# **BOARD OF SUPERVISORS**

**14APL-00000-00028**

**Appeal of the Planning Commission's Denial of the Kalasky  
Addition and Remodel**

**Case No. 14BAR-00000-00030**

East Elevation (Street) Proposed  
Scale: 1/8" = 1'-0"

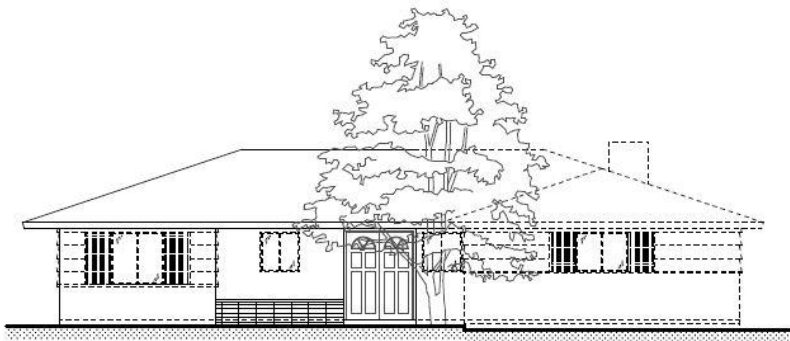
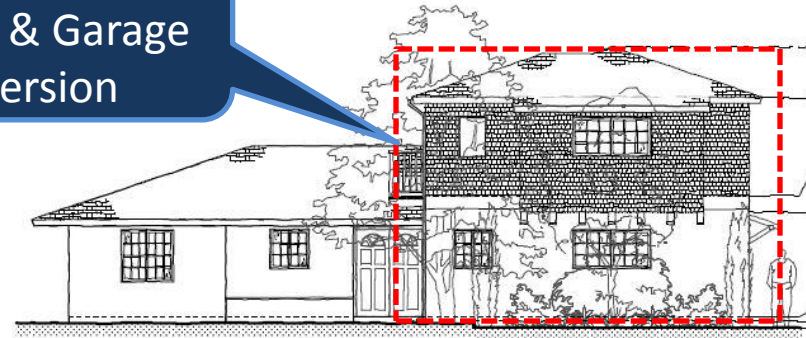
- Project fails to adhere to Second Story Guidelines 4.6 & 4.7 of Eastern Goleta Valley Design Guidelines
- Project does not comply with LUDC Section 35.82.070

- Guideline 4.6: *set the highest point of the second story back from the property line and to the center of the first story*
- Guidelines 4.7: *avoid locating the second story only over the garage or any one portion of the dwelling*
- SBAR and Planning Commission cited inconsistency w/ Guidelines 4.6 & 4.7
